SUBJECT: Waterford SES Unit No. 3
Docket No. 50-382
Significant Construction Deficiency No. 88
"Refueling Water Storage Pool Nozzle/Liner Overstressed Condition"

In response to the specific questions raised by the NRC inspector during the review of SCD-88, a recalculation was performed using the resultant of the two bending moments as the maximum bending moment.

The reanalysis results indicate that the actual stresses are still within allowable stress limit.

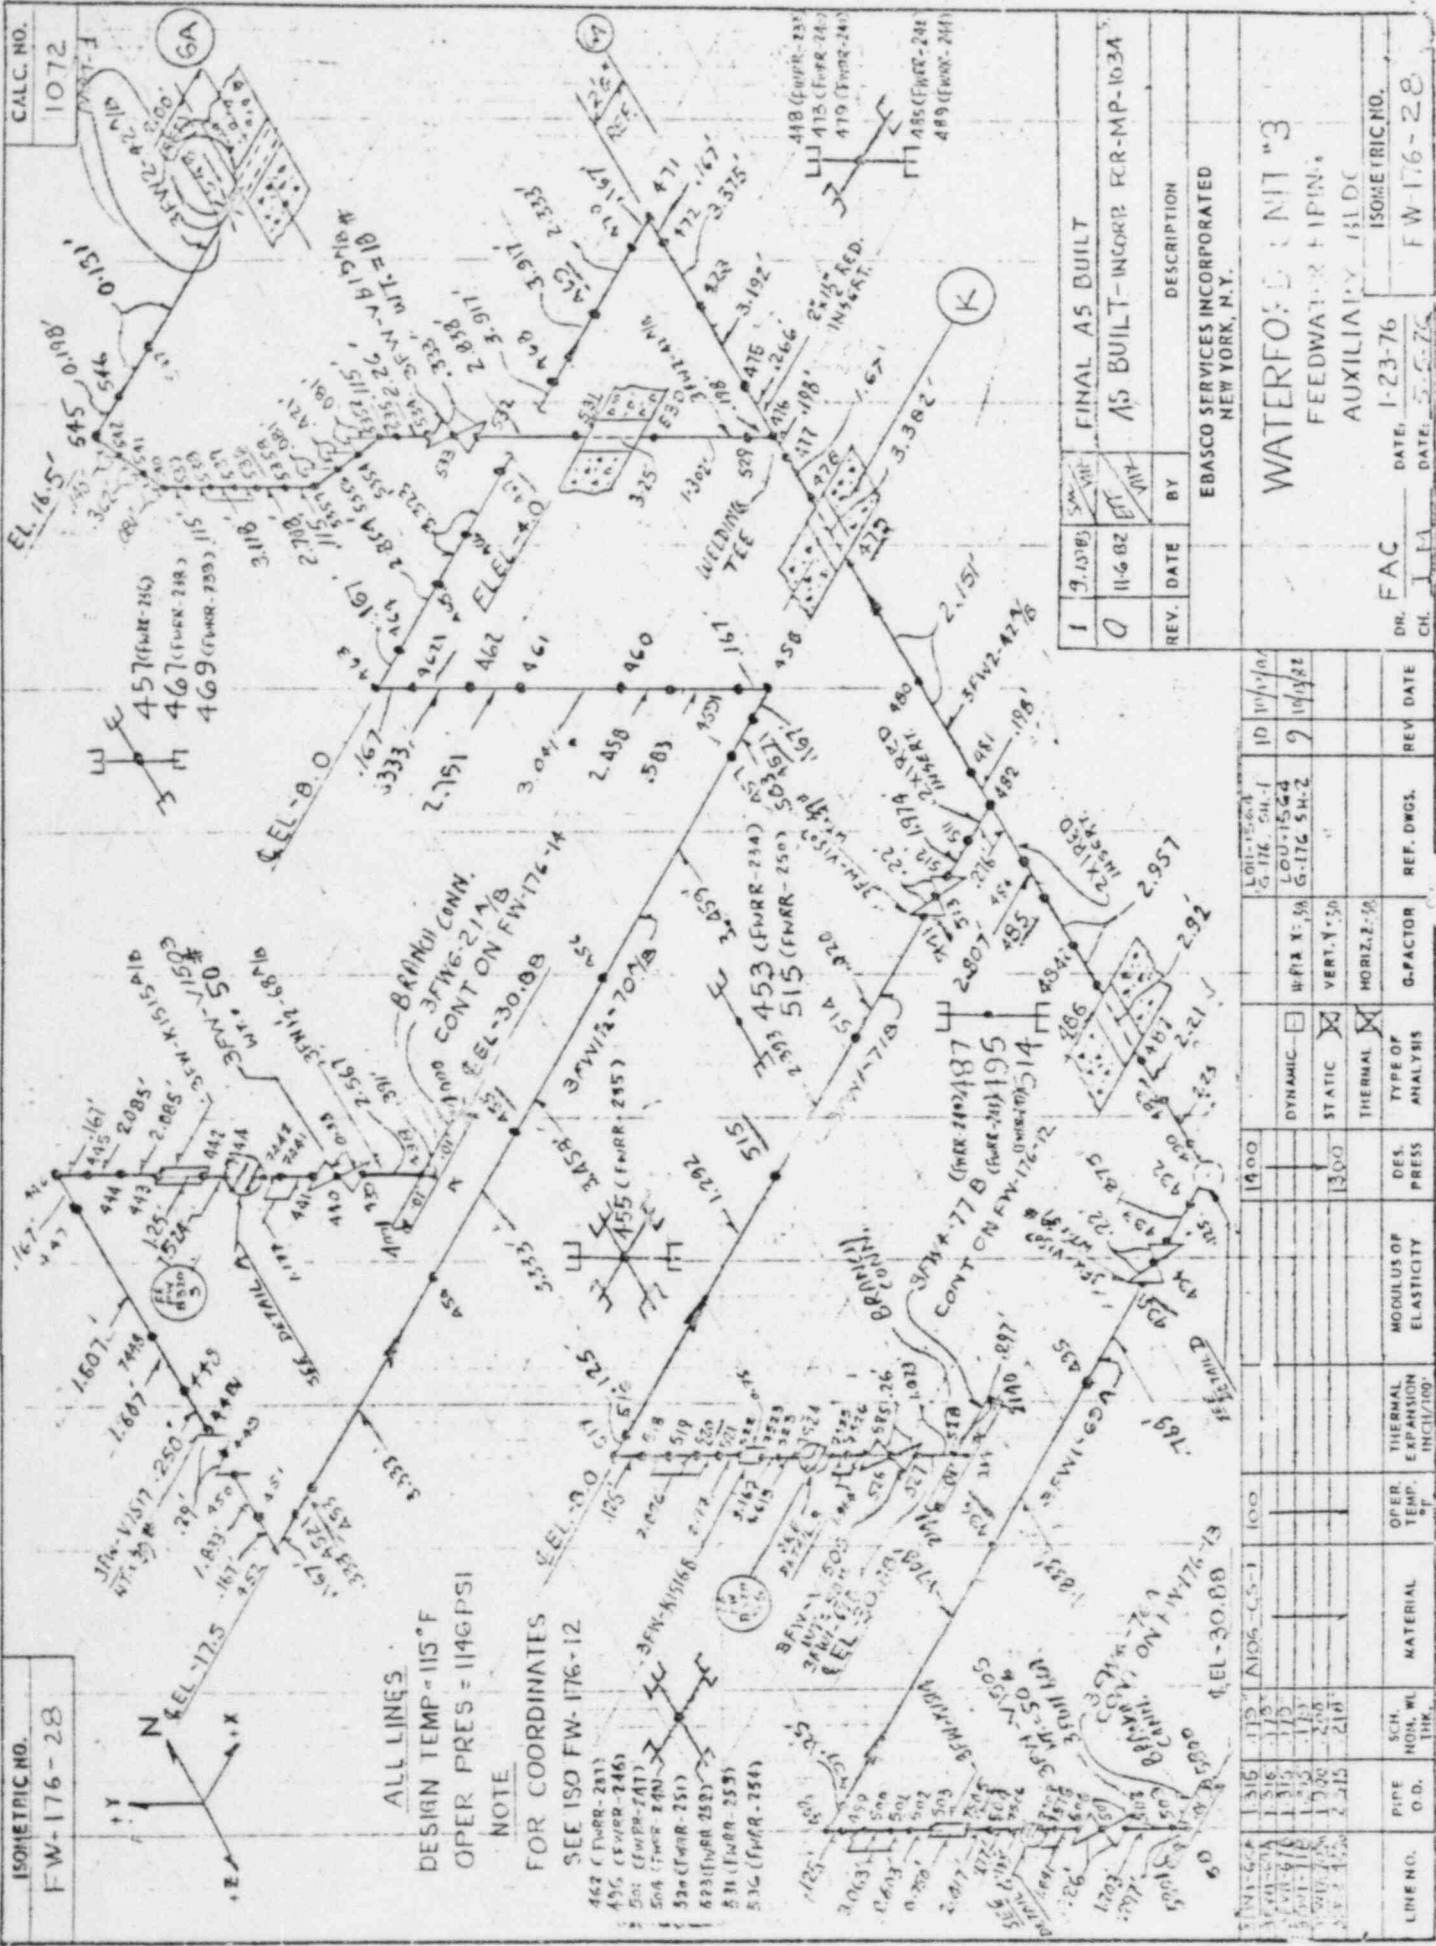
OK BY INSPECTION, RESULTANT MOMENTS
 ARE LESS THAN THOSE OF NOZZLE Pw 20 SEE CALC'S FOR
 Pw 20.
